Technical Service Information

FORD CD4E NEW DESIGN 2/4 SERVO PISTON AND RETURN SPRING FOR 1997

Figure 1
AUTOMATIC TRANSMISSION SERVICE GROUP

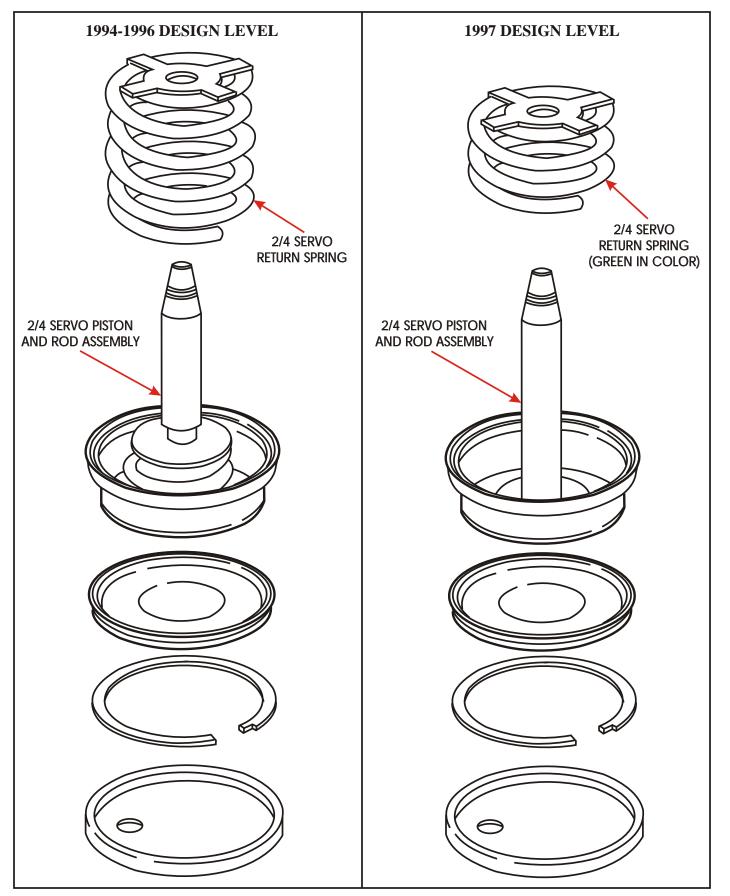
CHANGE: Beginning at the start of production for 1997 Probe models equipped with the CD4E transaxle, will contain a revised *one piece* intermediate/overdrive servo piston and rod assembly, and a new design servo piston return spring assembly, which is now green in color (See Figure 1).

REASON: Improved durability and calibration changes.

- (1) SERVO PISTON AND ROD ASSEMBLY 1997 Probe models are now a one piece design as shown in Figure 1.
- (2) SERVO RETURN SPRING ASSEMBLY Now has a revised return spring (Shorter) and is green in color for identification, as shown in Figure 1.

If replacement of the intermediate/overdrive servo piston assembly becomes necessary in a 1997 CD4E transaxle, you *must* use the new design level parts listed below.

2-4 Piston And Rod Assembly, 97 Models (No Grooves)	F7RZ-7H188-CA
2-4 Piston And Rod Assembly, 97 Models (1 Groove)	F7RZ-7H188-BA
2-4 Piston And Rod Assembly, 97 Models (2 Grooves)	F7RZ-7H188-AA
2-4 Servo Return Spring, 97 Models (Green)	F7RZ-7H073-AA
